FINAL
AS-BUILT BASELINE
MONITORING REPORT (MY0)

MAJOR HILL STREAM AND WETLAND MITIGATION SITE
Alamance County, North Carolina

DMS Project ID No. 100015
Full Delivery Contract No. 7193
USACE Action ID No. SAW-2017-01472
DWR No. 17-0921
RFP No. 16-006990

Subject: Major Hill Stream and Wetland Mitigation Site: As-built Comment Responses
DMS Contract #: 7193; DMS Project ID: 100015; RFP # 16-006990

CURRENT CONDITIONS PLAN VIEW
 Major Hill Stream and Wetland Mitigation
 Alamance County, North Carolina

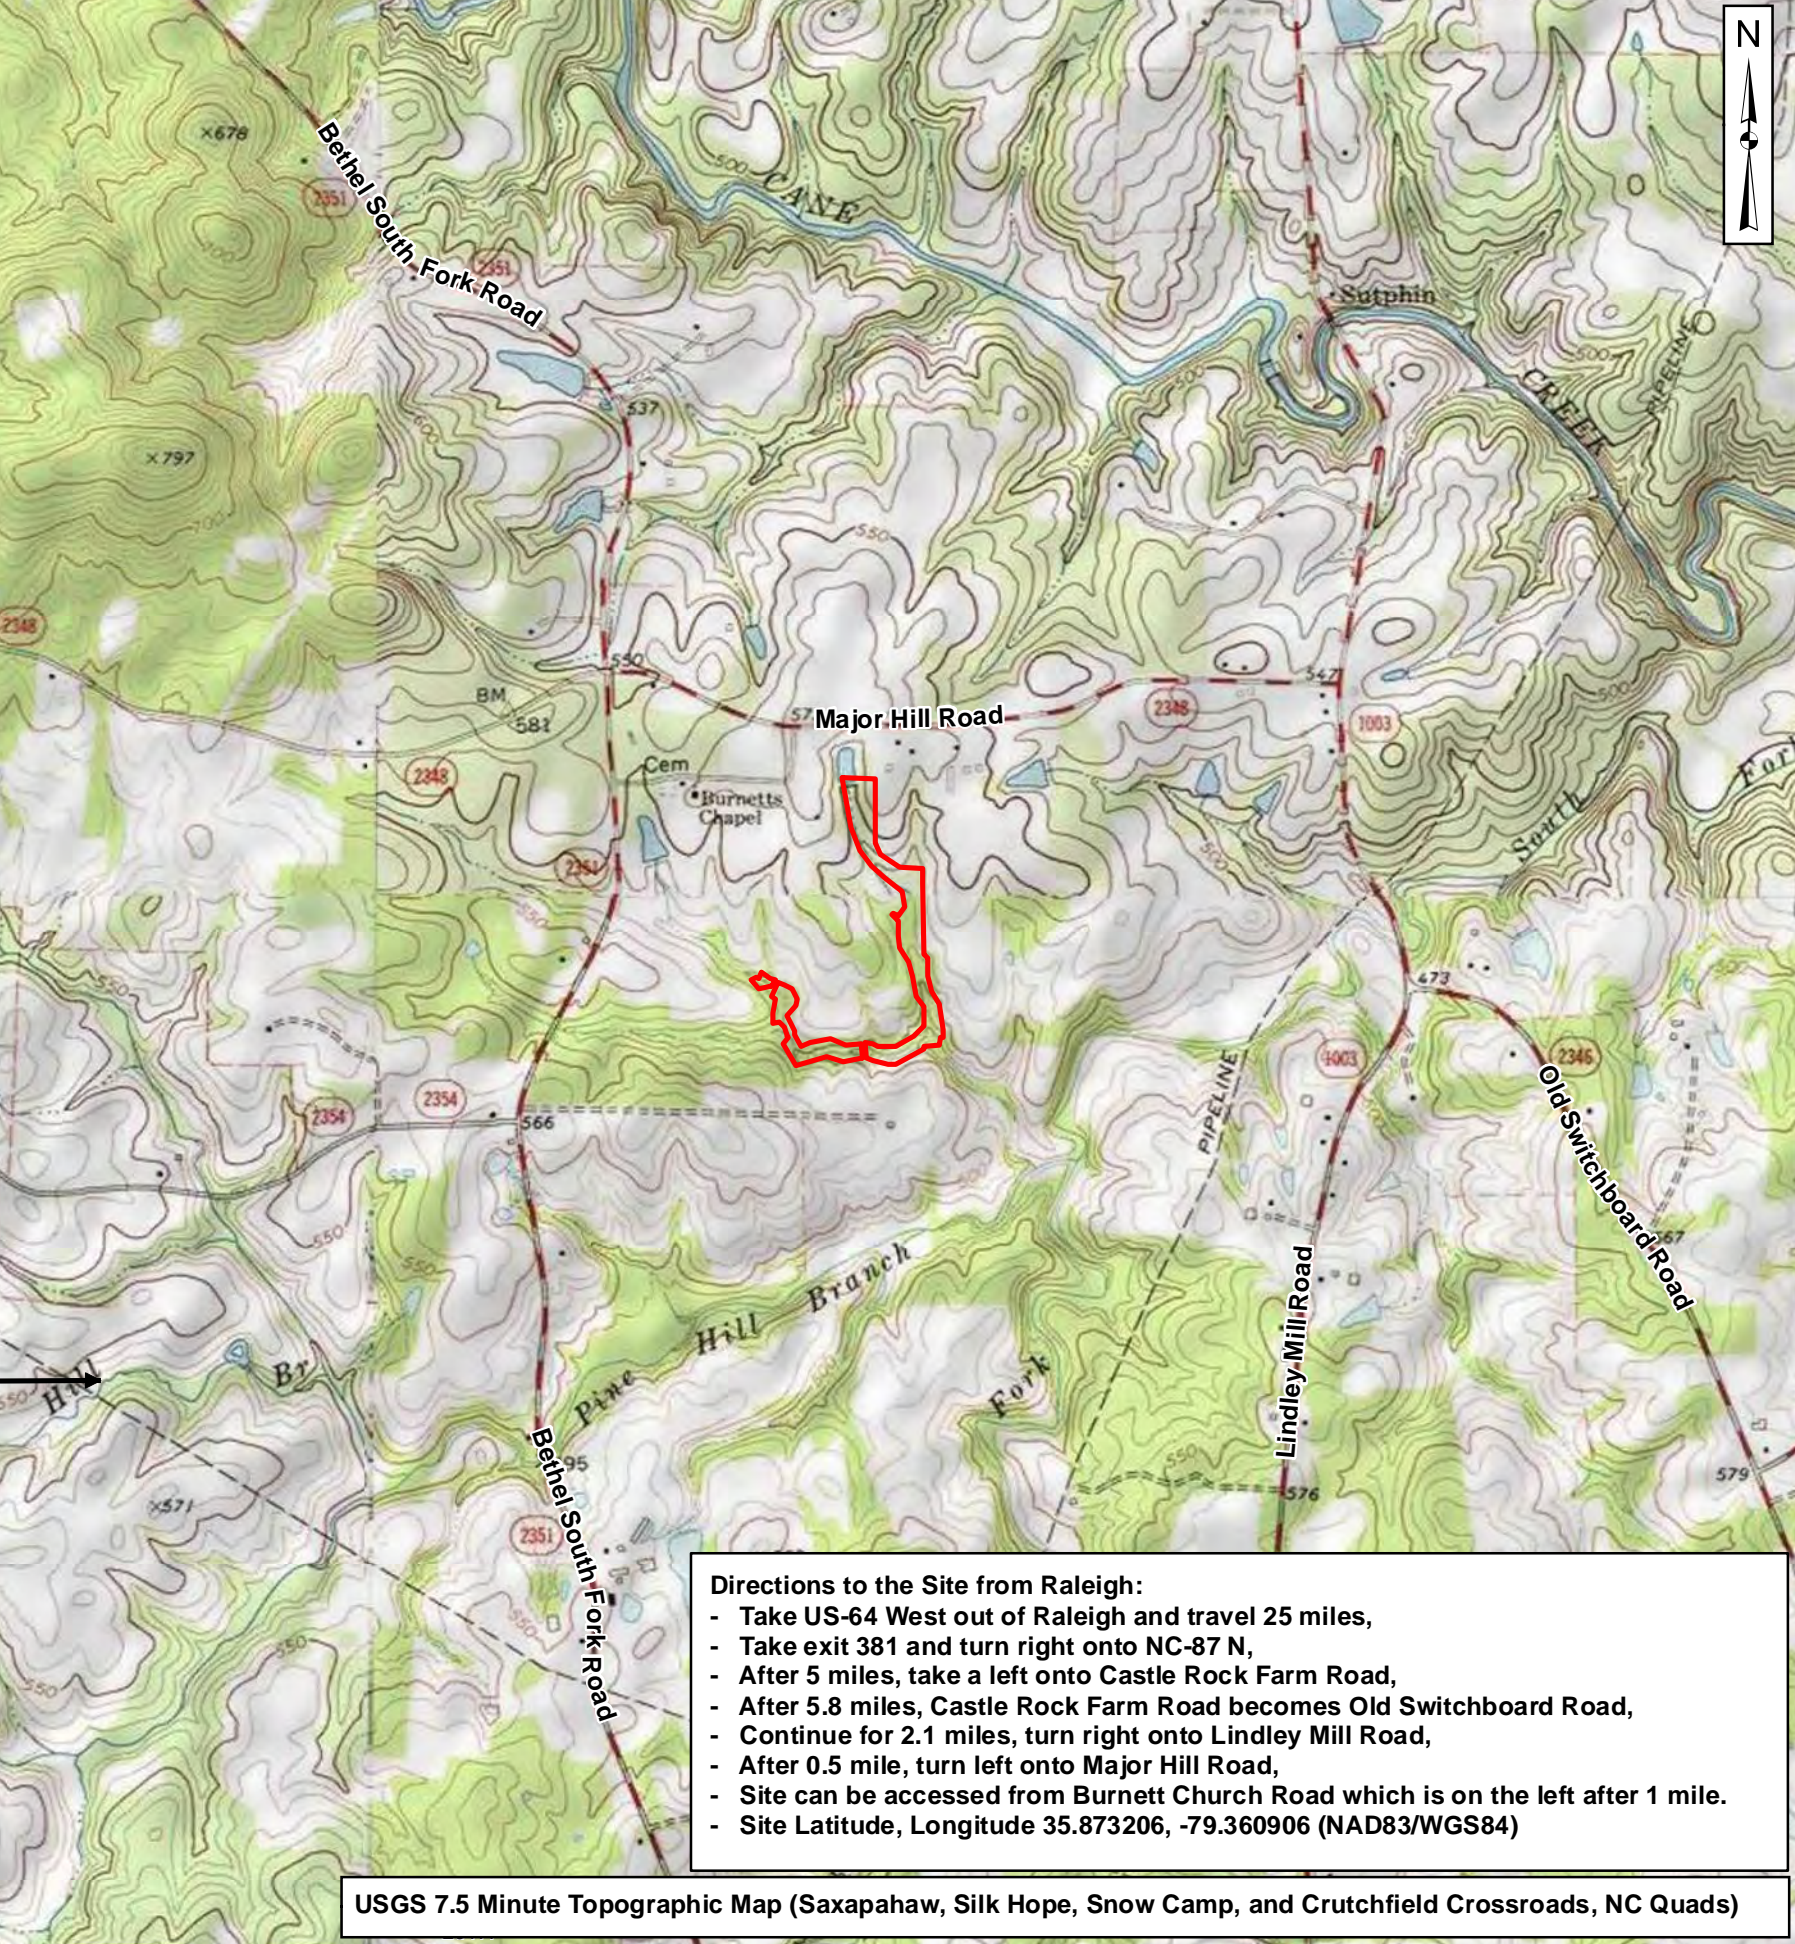
- Table 2, the RFP issue date is 9/16/2016. Add 404 permit date to table (6/28/2018, see excel table guidance). *This was adjusted/added.*
- Figure 2, CCPV, Please increase text on legend so it is more legible. Show location of fences on CCPV. *Font size in the legend was increased, and fences were added to the CCPV.*

SHEET NAME	SHEET NUMBER
AS-BUILT STRUCTURES	4
PROJECT NAME: MAJOR HILL STREAM AND WETLAND RESTORATION SITE	
COUNTY: ALAMANCE	DATE: 2018

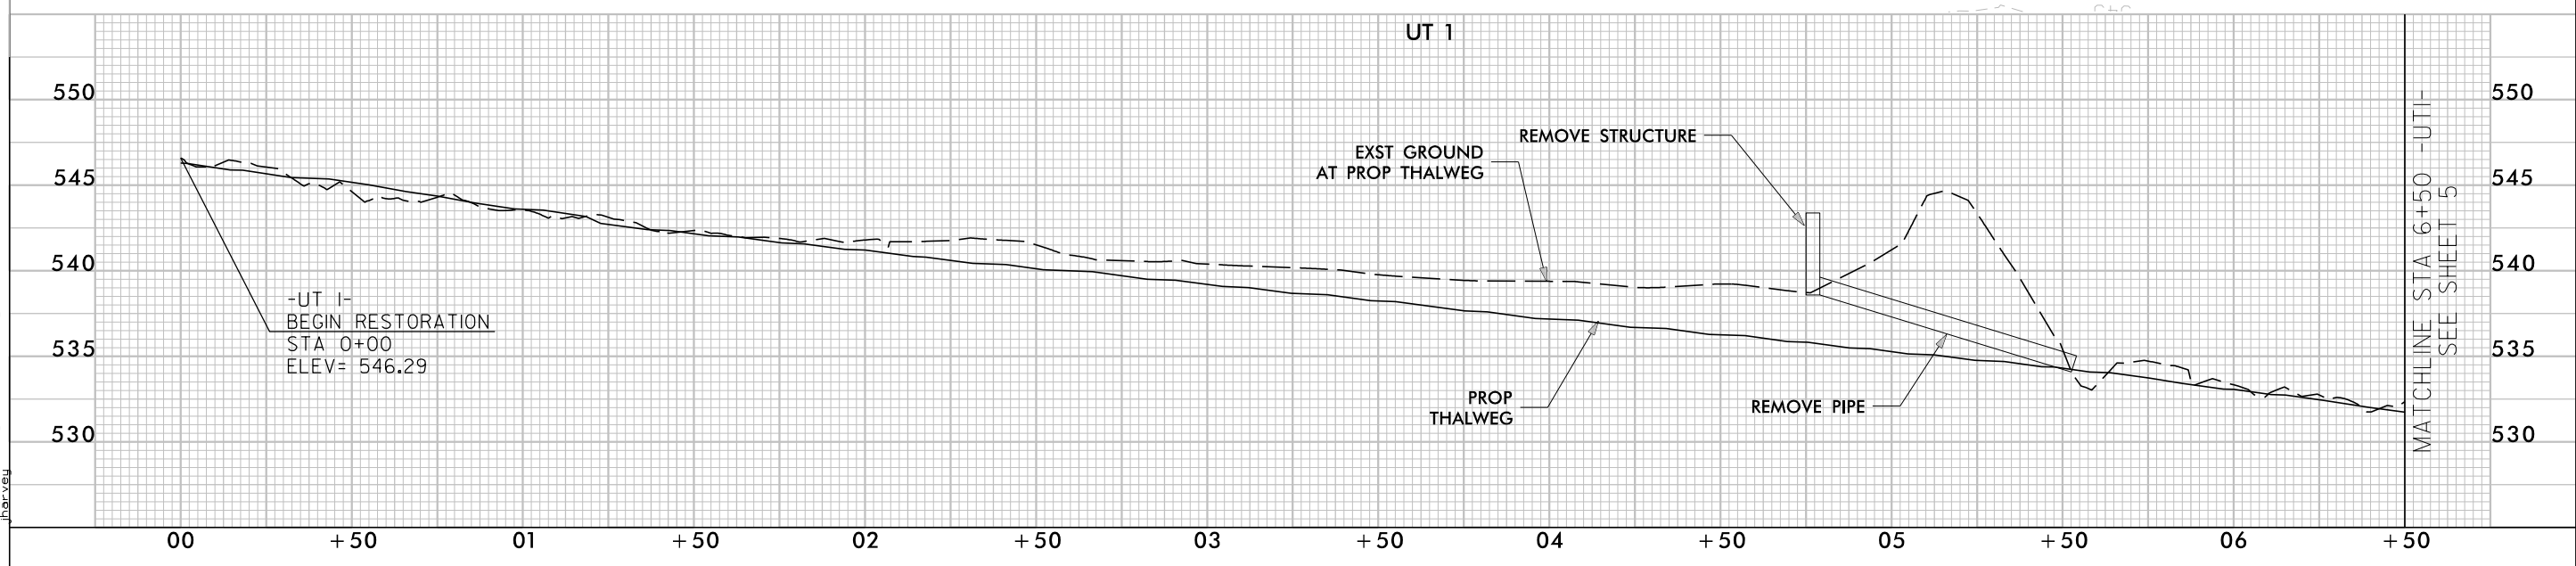
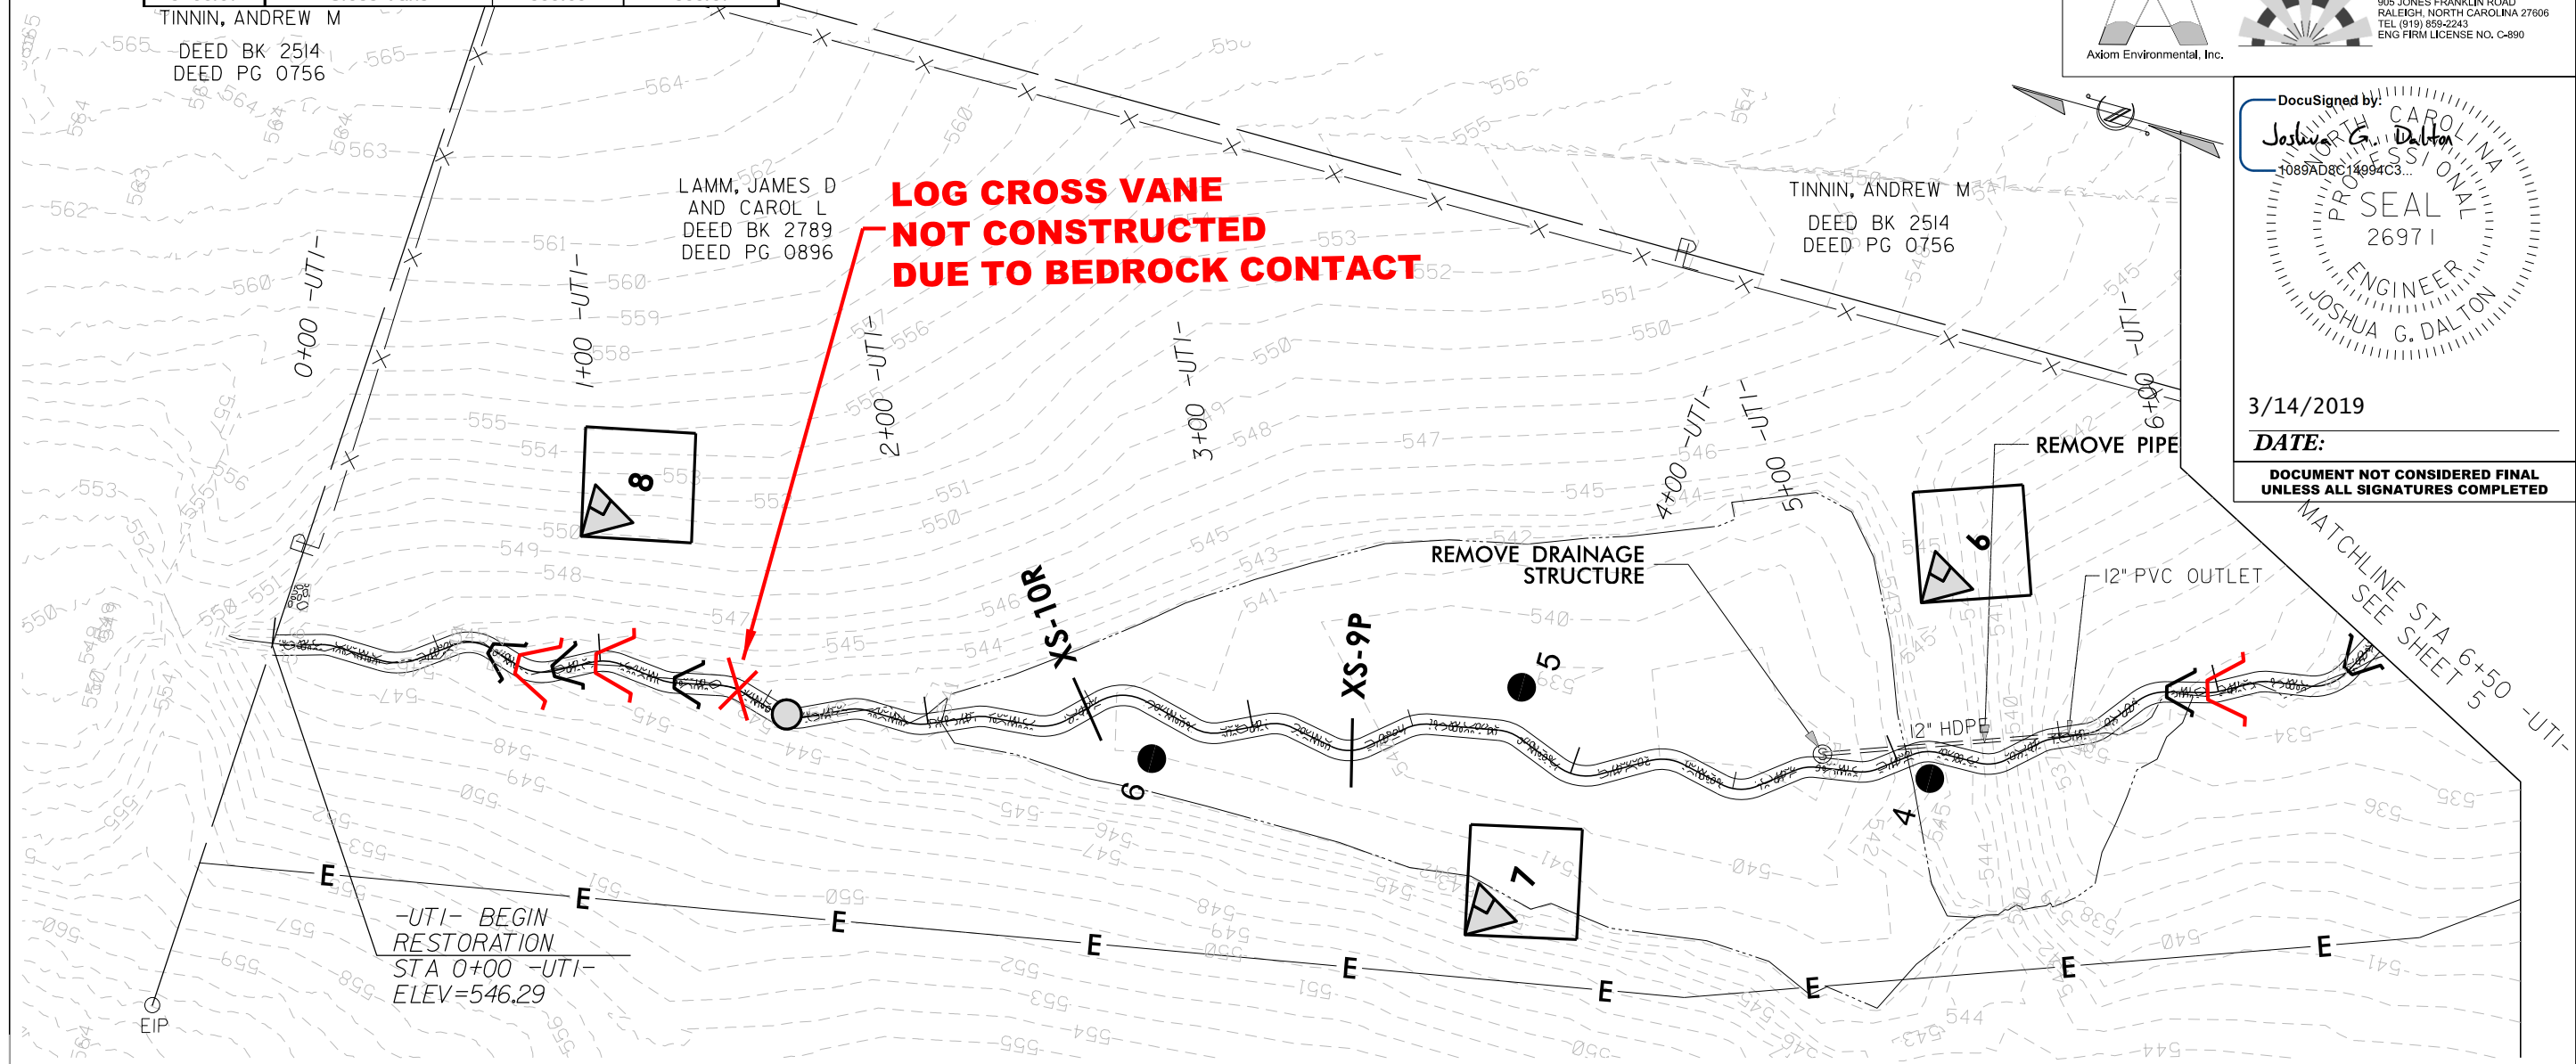
- There were some structures that were not constructed, but there is no explanation as to why or how the grade was maintained. Please provide text explanation. *A note has been added to the construction drawings to indicate that the structures were removed due to contact with bedrock.*

CONSTRUCTION PLANS DATED 07-23-2018 INCORRECTLY SHOWED SEVERAL STRUCTURES AT THE HEAD OF A RIFFLE. THESE STRUCTURES WERE FIELD ADJUSTED AND CONSTRUCTED AT THE TAIL OF RIFFLE/HEAD OF POOL.
